ADDENDUM NO. 1

FLEET MAINTENANCE FACILITY EXPANSION

CITY OF DUBLIN, OHIO

Project No. 213052.00

DRAWING
ADDENDUM DRAWING NO. G-1B

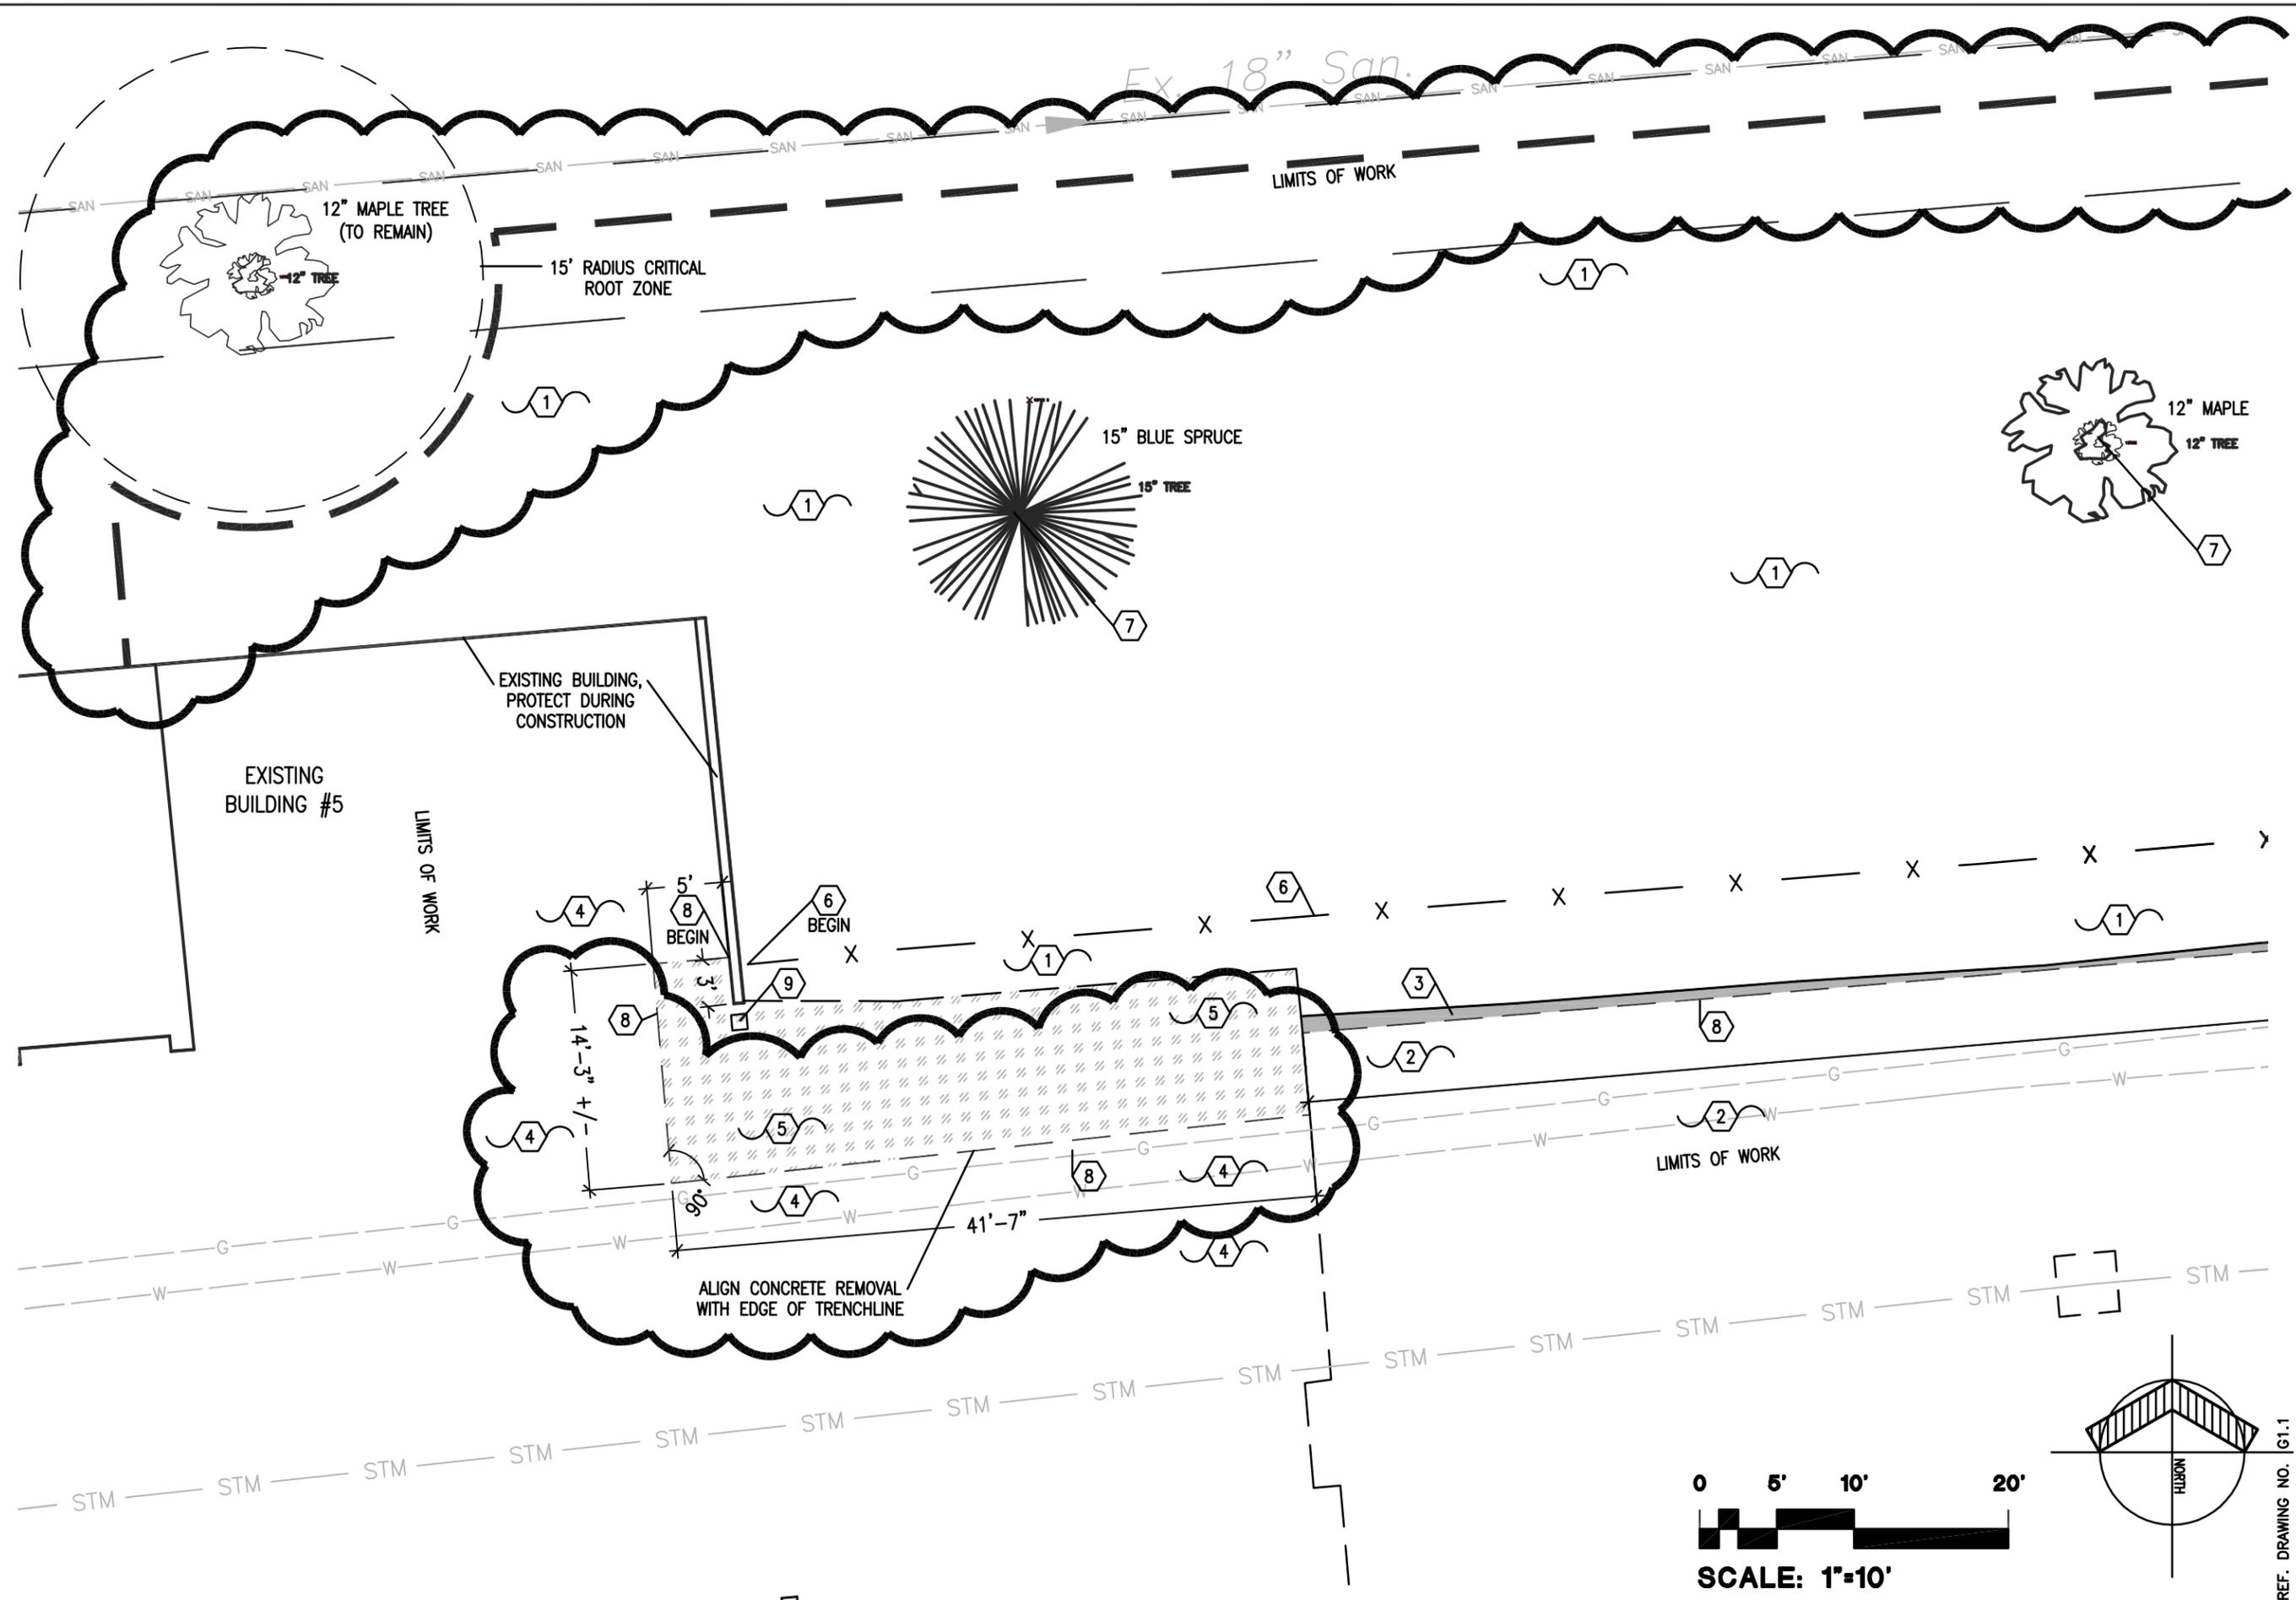
- A. Remove additional concrete and change the limits of work. Refer to Addendum Drawing No. G-1A and G-1B.
- B. Change grading and slit fence location. Refer to Addendum Drawing Nos. G-2A and G-2B.
- C. Add concrete pavement and change the limits of work. Refer to Addendum Drawing No. G-3A and G-3B.
- D. Deleted stray section 3/S1.2 from the Foundation Plan. Refer to Addendum Drawing Nos. S-1.
- E. Revise section 1/S1.2. Refer to Addendum Drawing Nos. S-2.
- F. Revise Elevation A/S1.3. Refer to Addendum Drawing Nos. S-3.
